## RE: Bracing revision for Lot #116 Reserve at Stoney Creek- 1924 SW Hightown Dr, Lee's Summit, MO 64082 -Permit # PRRES20215839

Bracing Revision shall be as follows

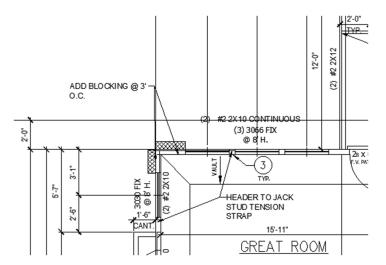
- Block wall a 3' O.C. in bracing areas indicated in picture.
- Seheathing shall be nailed @ 12" O.C. field and 6" O.C. edge.
- Nail sheathing to blocking at 6" O.C.
- Strap blocking to adjacent studs with CS 16 strap.
- See image below
